**TWIN CITY WATER AND SEWER DISTRICT EAST 1ST ST., UHRICHSVILLE, OHIO
TUSCARAWAS COUNTY, OHIO
PROPOSED
WATER MAIN AND PAVEMENT RESURFACING**

ADDENDUM # 1

**JANUARY 20, 2021
Thrasher Project #101-010-10014**

TWIN CITY WATER AND SEWER DISTRICT
 EAST 1st. STREET, UHRICHVILLE, OHIO
 WATER MAIN AND PAVEMENT RESURFACING
 TUSCARAWAS COUNTY, OHIO
 STORM SEWER PROFILES

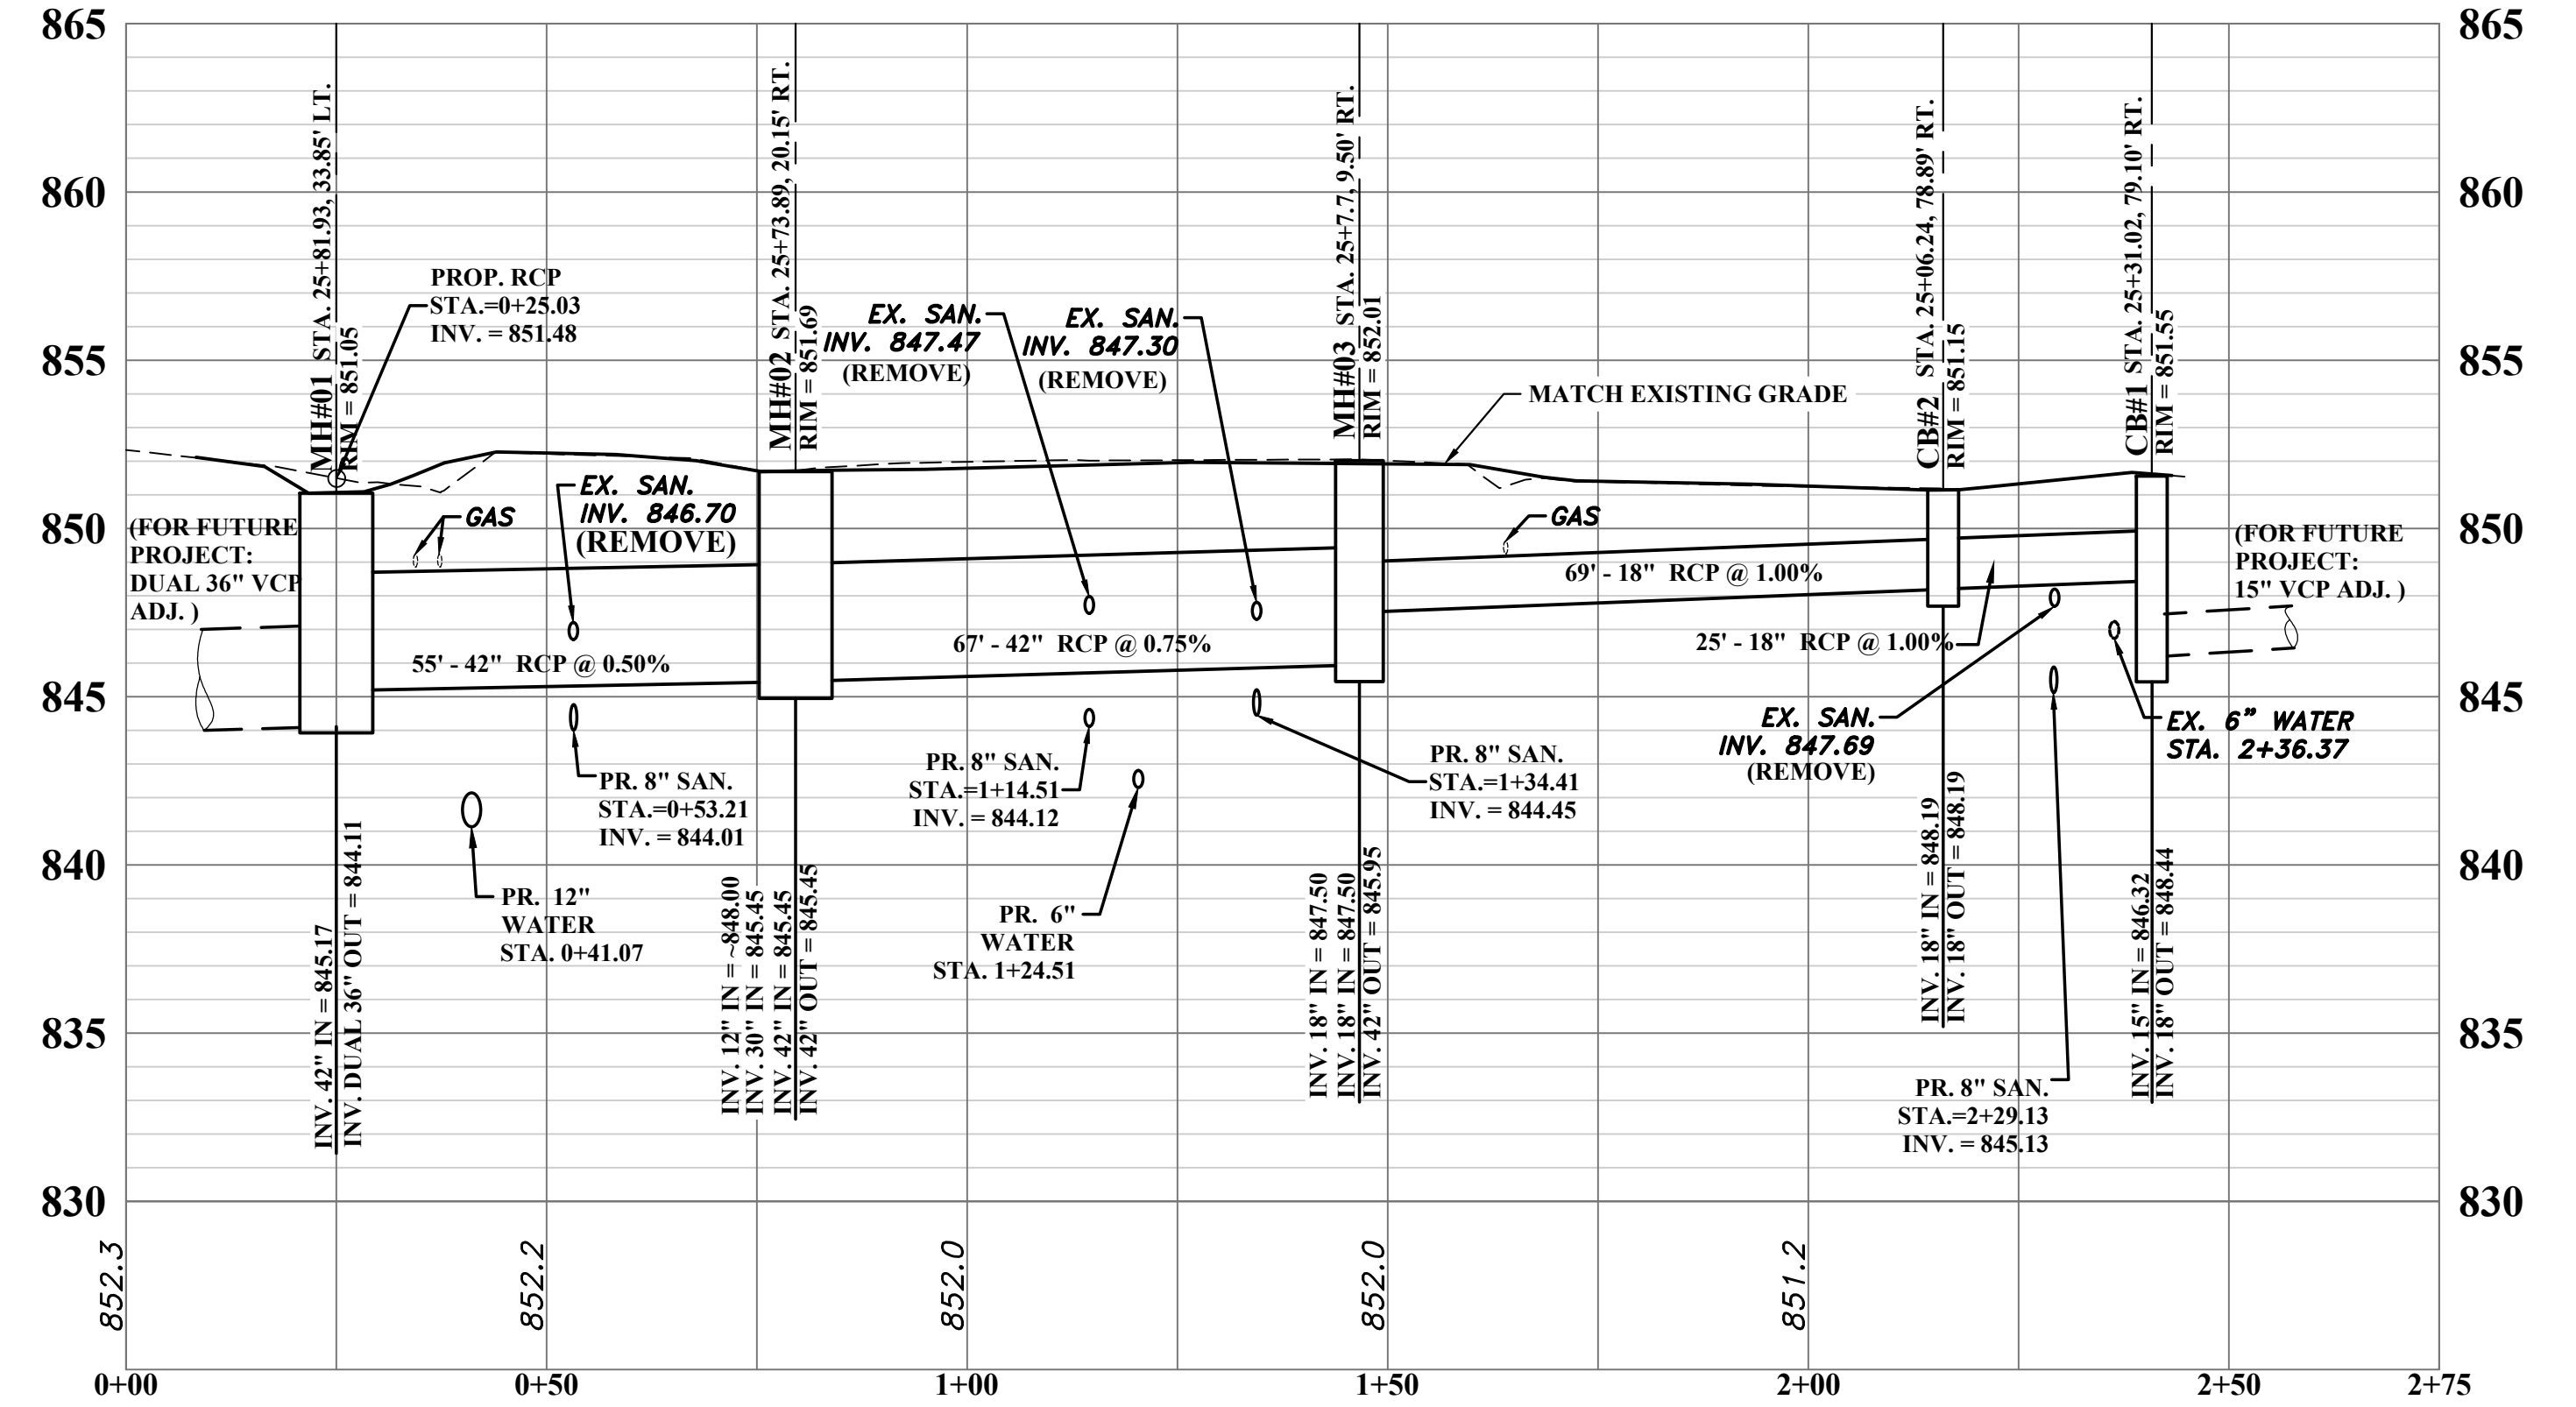
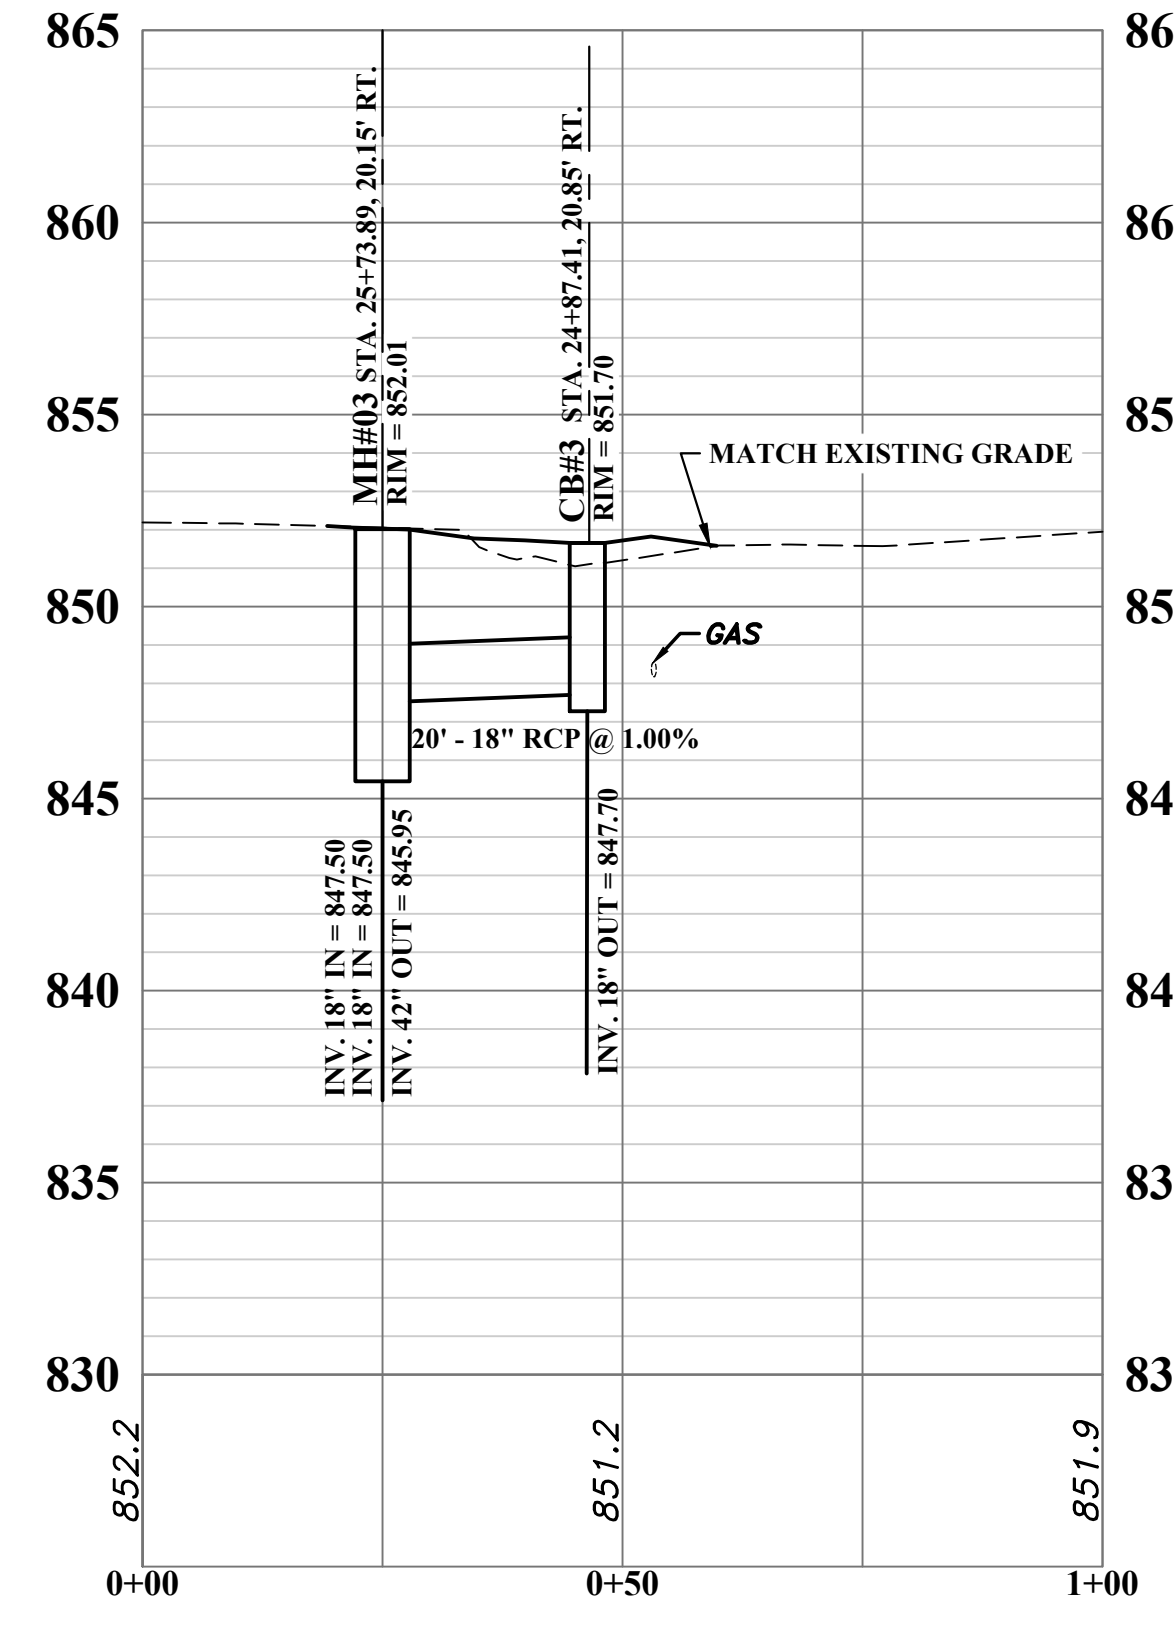
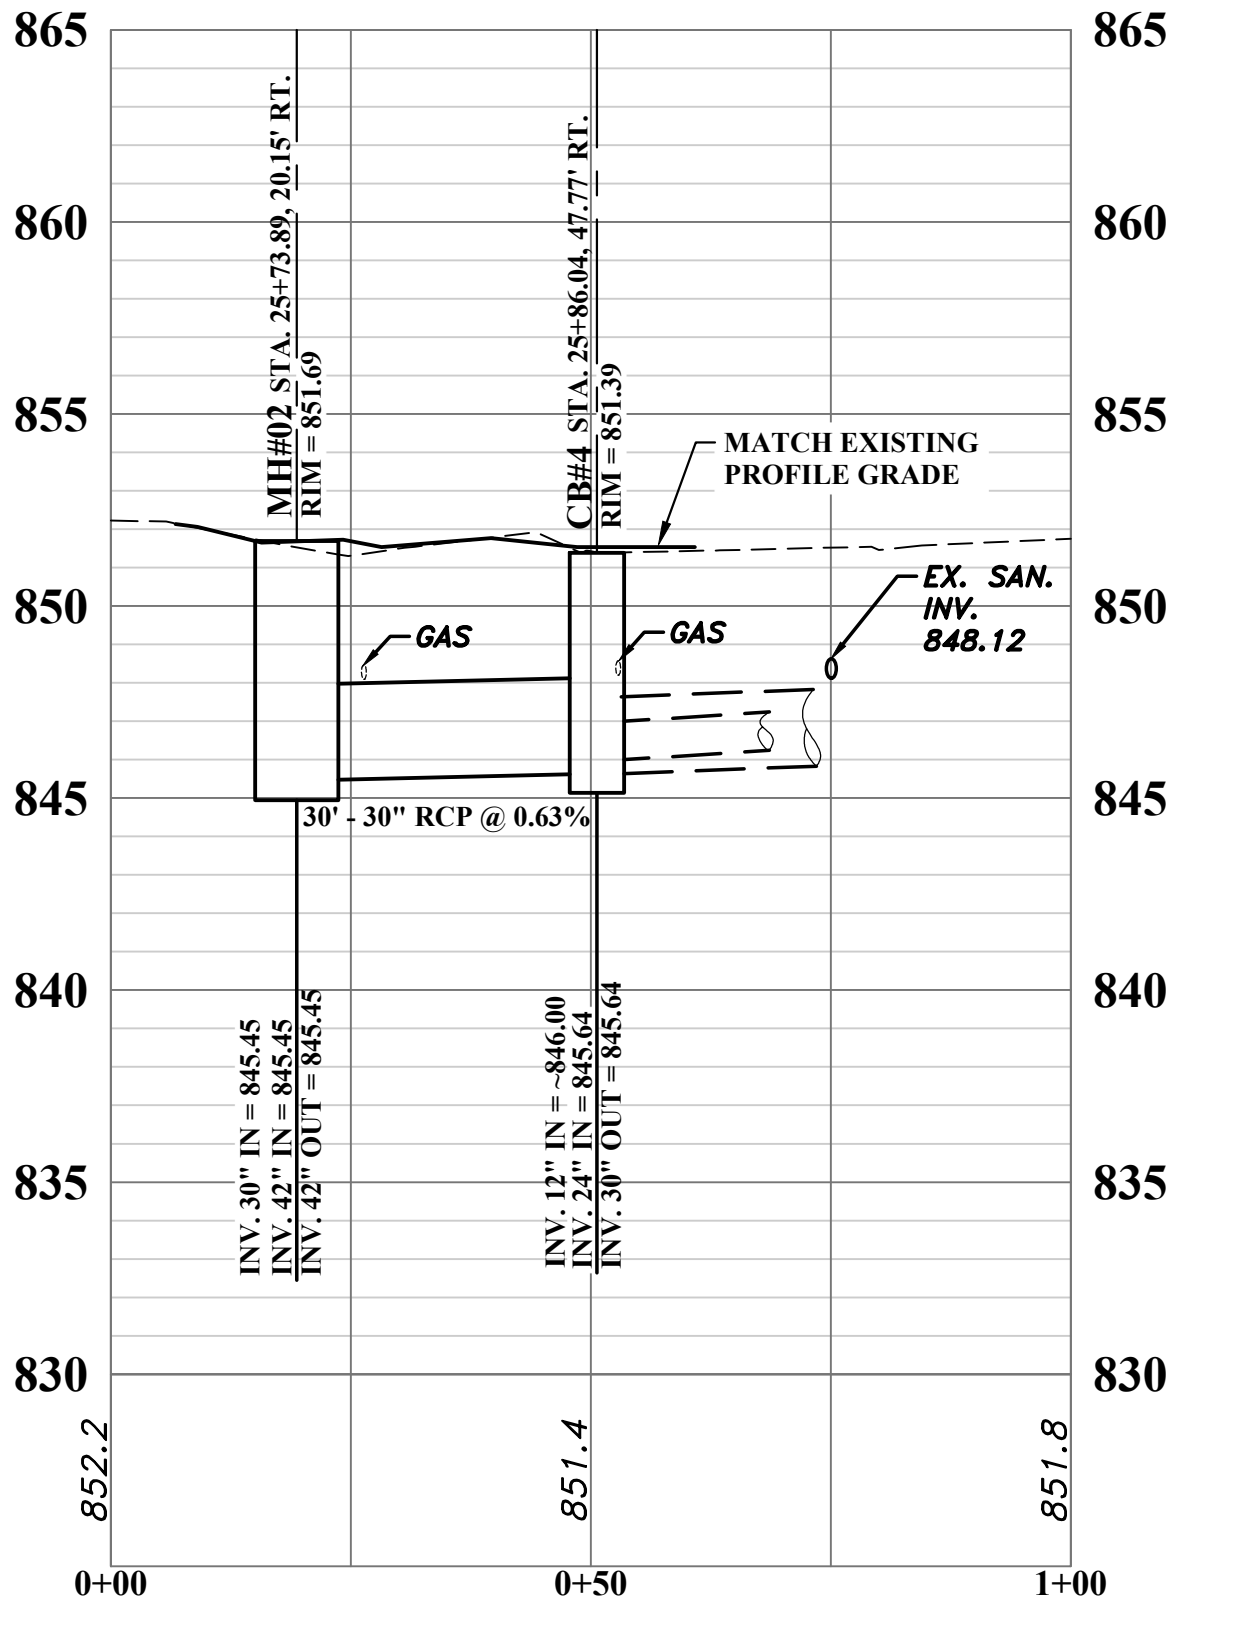
- Changed 8” PVC SDR-35 from 550 LF to 238 LF
7. Plan Sheet 15: Storm Sewer Profiles
 - Added storm sewer text
 8. Plan Sheet 16: Sanitary Sewer Profiles
 - Removed the text “Remove and Replace” from sanitary manholes A,B,C and E
 - Revised existing sanitary text
 9. Plan Sheet 19: Standard Details
 - Changed waterline trench detail with crushed stone cover to sand
 10. Plan Sheet 20: Standard Details
 - Changed Utility Trench Detail label to read Storm/Sanitary Utility Detail
 11. Plan Sheet 22: Standard Details
 - Added Sanitary Manhole Drop Structure detail
 12. Plan Sheet 24: Standard Details
 - Added Catch Basin/Manhole #4 Detail
 - Changed the max outlet diameter for MH#4 Detail from 24” to 30”

8. Manhole number three will need to be larger than 72" dia as the pipe holes for the 42" rcp pipe will overlap by 5-6" as the pipe is at 90 degrees.

MH#3 has been upsized to 96" I.D. for more conservative construction tolerances.

NO.	BY	DATE	DESCRIPTION
1	JAB	1/19/21	ADDENDUM#1 - UPSIZED MH#3 FROM 72" TO 96" I.D.
